Nant Mithil Energy Park, Powys.
PEDW DNS Application Ref: DNS CAS-01907-D7Q6Z1.

CPRW-RE-think Chapter 7 on

Access Traffic and Transport

Evidence by CPRW-ReThink on:

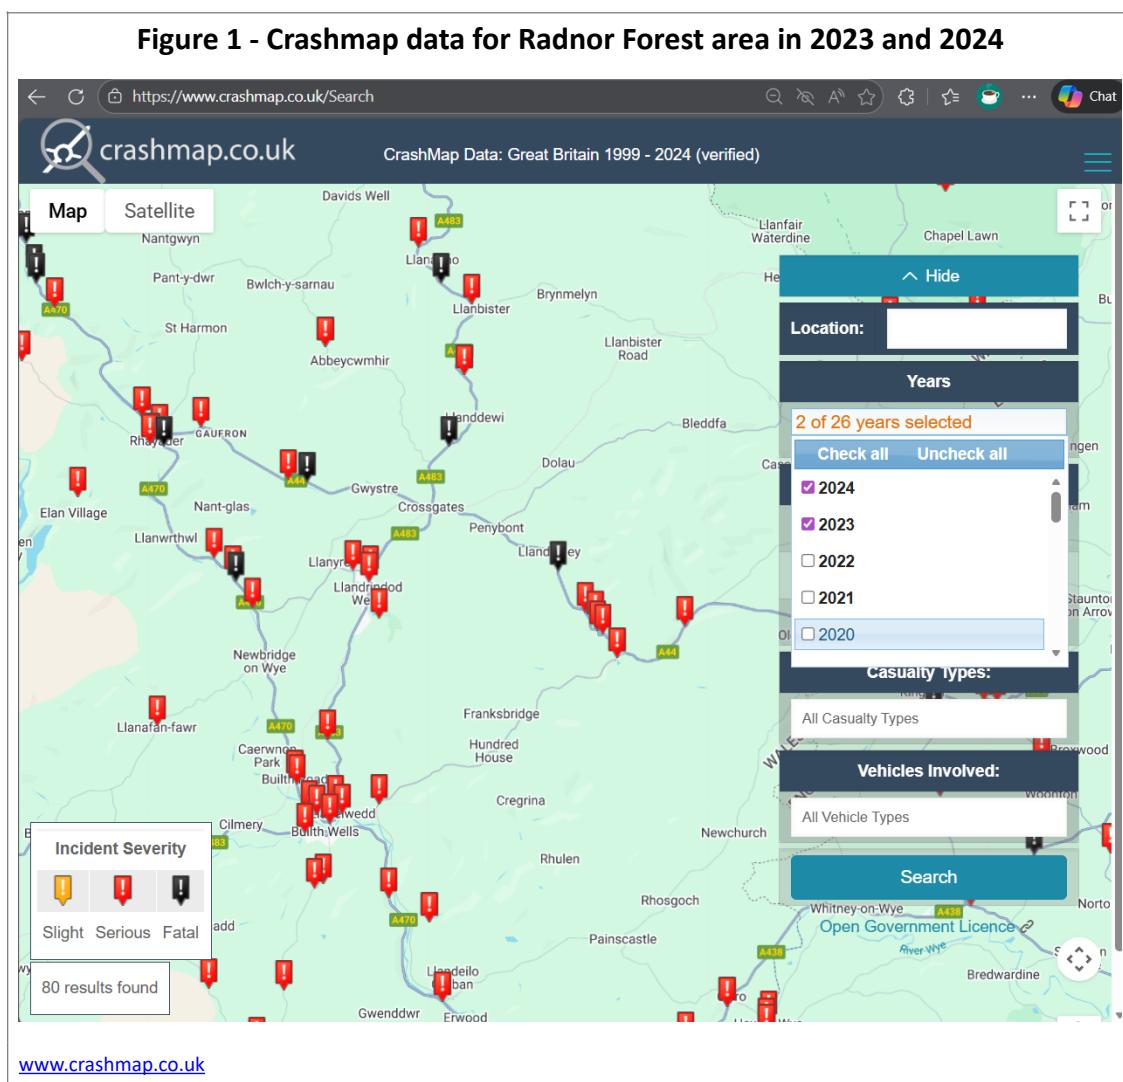
- 2.2. Section 10.46 and Section 5.7, Construction Traffic Profile in ES Vol 03 App. 10.01 to 10.02 – Transport Appendices, uses Personal Injury Accident (PIA) data from 2018-2022. The source of the Accident data is stated as being from the website – www.crashmap.co.uk; According to the Welsh Government website <https://www.gov.wales/reported-road-casualties>, and <https://statswales.gov.wales/Catalogue/Transport/Roads/Road-Accidents/accidents/ksiroadaccidents-by-area-year>; the number of serious and fatal accidents on the roads of Powys increased significantly in the years 2023 and 2024. This can be reflected by the view on www.crashmap.co.uk showing only the serious and fatal accidents in the years 2023 and 2024 (figure 1).

- 2.3. It is evident from the crash data that the main roads around the Radnor Forest site and those used by construction traffic are already roads with a high number of fatal and serious accidents. The significant increase in HGV traffic on these roads by the applicant and their subcontractors will only make the roads more dangerous and there is real concern that these additional HGVs will cause accidents on the local road network resulting in more serious and fatal incidents.

Figure 2 - Google Street view image of road bridge on A44 near Crossgates

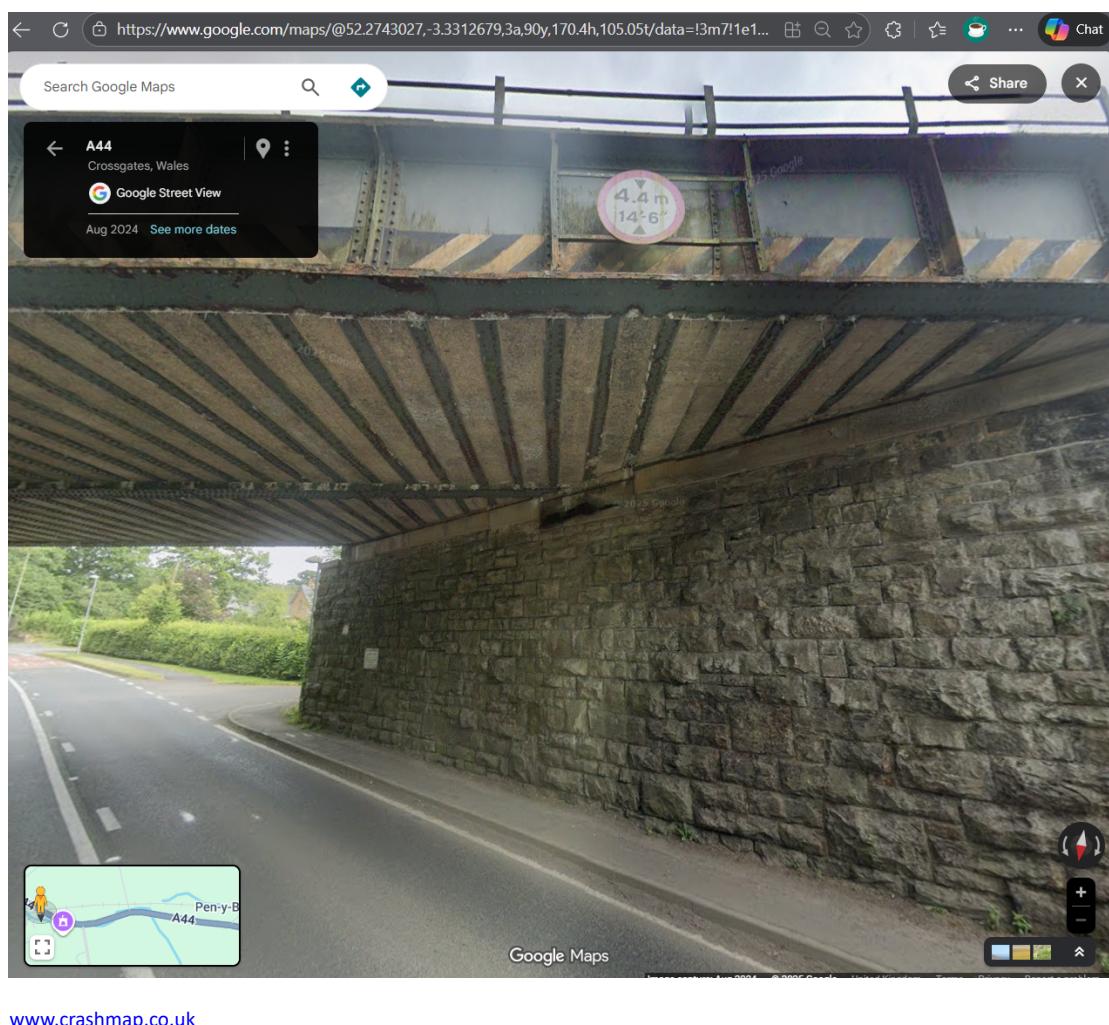
3.10. There are several locations along the route with bridges which are lower in height than the maximum height/min diameter of the turbines on an AIL, which is stated in Table 1 of Section 2.3 of the App. 10.1 and 10.2 as being 4.8m for a tower section. There is no mention in the submission how the turbine can pass under a bridge which for instance is only 4.4m in height (fig. 2).
